City of El Paso – City Plan Commission Staff Report

Case No: SUSU16-00019 Painted Desert at Mission Ridge 2
Application Type: Major Combination
CPC Hearing Date: May 19, 2016
Staff Planner: Armida Martinez, (915) 212-1605, martinezar@elpasotexas.gov
Location: West of Darrington and North of Paseo Del Este
Acreage: 39.412
Rep District: ETJ
Existing Use: Vacant
Existing Zoning: ETJ
Proposed Zoning: ETJ
Nearest Park: Proposed park within Painted Desert at Mission Ridge 1
Nearest School: Dr. Sue A. Shook Elementary (.25 miles)
Park Fees Required: N/A
Impact Fee Area: N/A
Property Owner: Hunt Mission Ridge, LLC.
Applicant: Hunt Mission Ridge, LLC.
Representative: CEA Group

ATTACHMENT 3

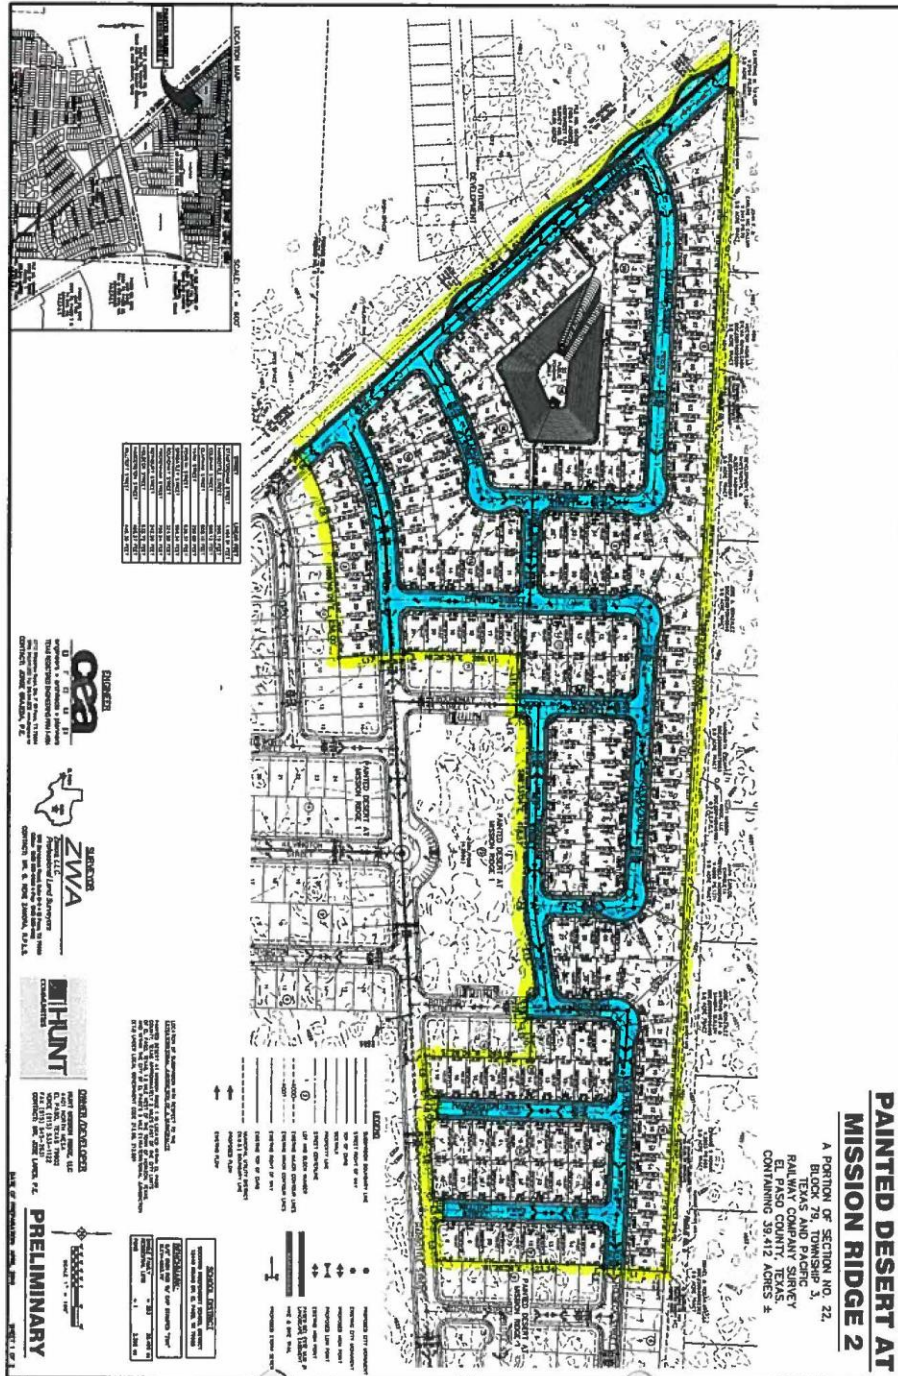
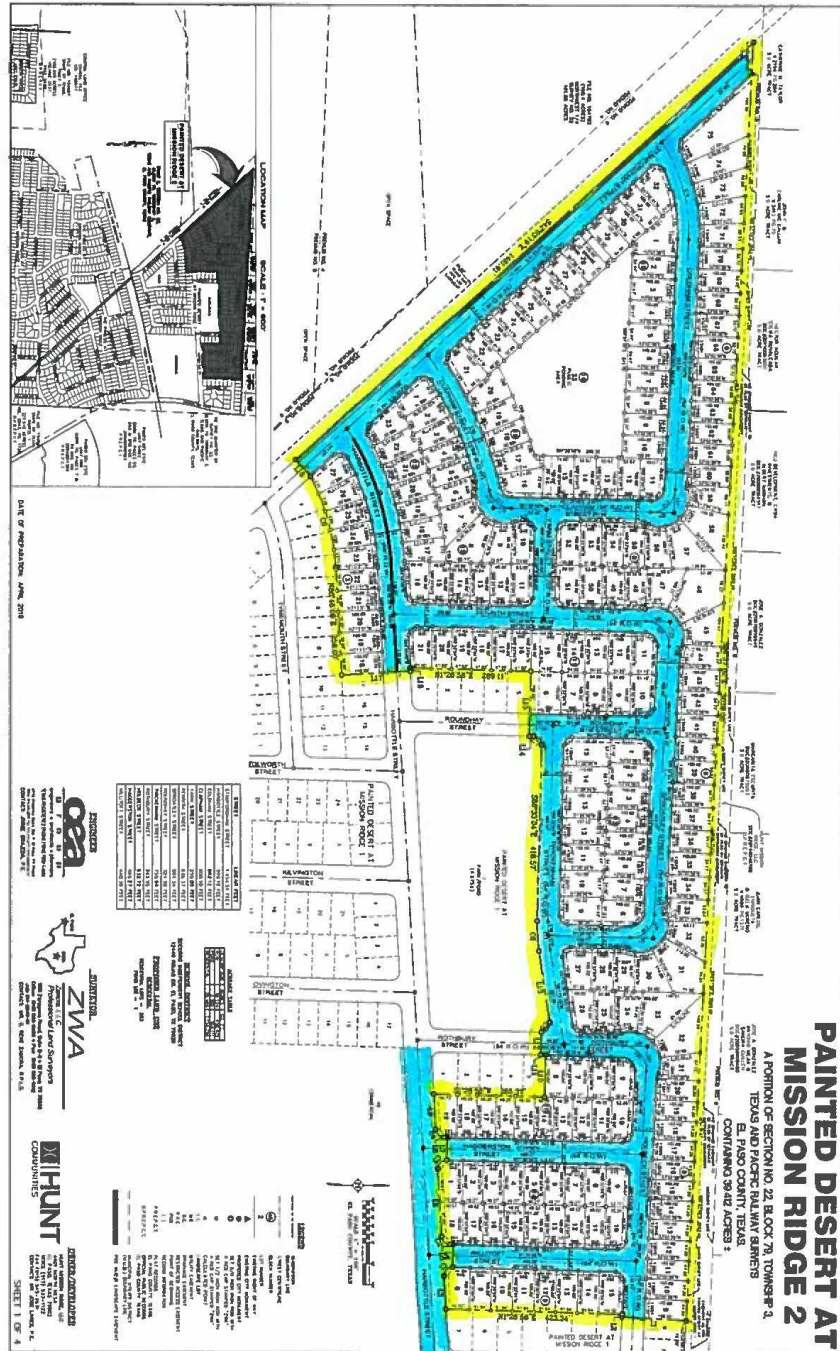
1. Identify the final destination of the runoff at north end of Stamford St.; is the street extending in the future? Run-off flowing from street ROW into undeveloped terrain must do so through an adequate temporary catch basin to avoid erosion of the street and terrain.

3. The developer shall be responsible for maintenance of all offsite storm-water management facilities unless drainage easements or rights-of-way with adequate access are provided; label drainage systems within Lot 18, between Lots 5 & 6 in Block 6 and whether they are public or private.

4. Verify if runoff from commercial Lot 18 Block 6 is designated for just the one pond and system or for both ponds and systems since inlets from both ponds are being provided. Verify if design capacities are adequate.

PAINTED DESERT AT
MISSION RIDGE 2
TYPICAL CROSS SECTIONS

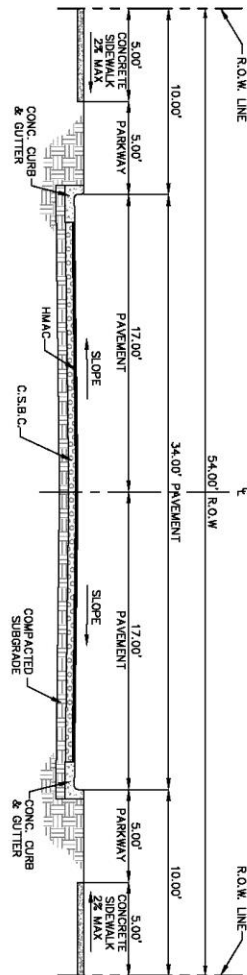
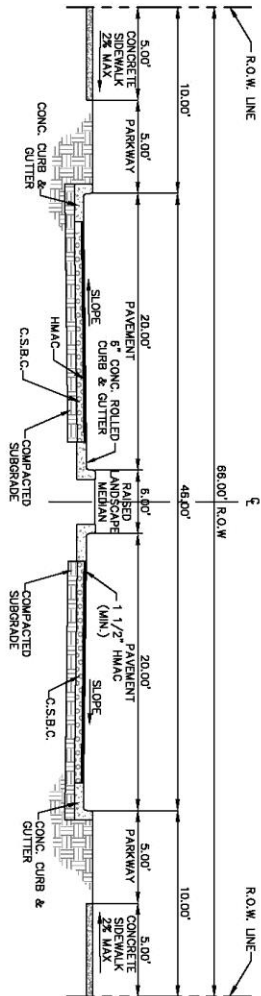
1. To allow a 54 ft. roadway cross-section with two 17 foot paved driving lanes with 6 inch curb and gutter on both sides of the roadway , two 5 foot parkways abutting the curb and two 5 foot concrete sidewalks for the proposed local streets.
2. To allow a 54ft. roadway cross –section with two 17 foot paved driving lanes with 6 inch curb and gutter both sides of the roadway, one 5 foot concrete sidewalk, one 5 foot parkway abutting the sidewalk, and one 10 foot hike and bike trail for Stamfordham Street.
3. To allow a modified 66 foot roadway cross-section with two 20 foot paved driving lanes with 6 inch curb and gutter on both sides of the roadway, a raised 6 foot landscaped median, two 5 foot concrete sidewalks, and two 5 foot parkways abutting the sidewalks for Harbottle Street.
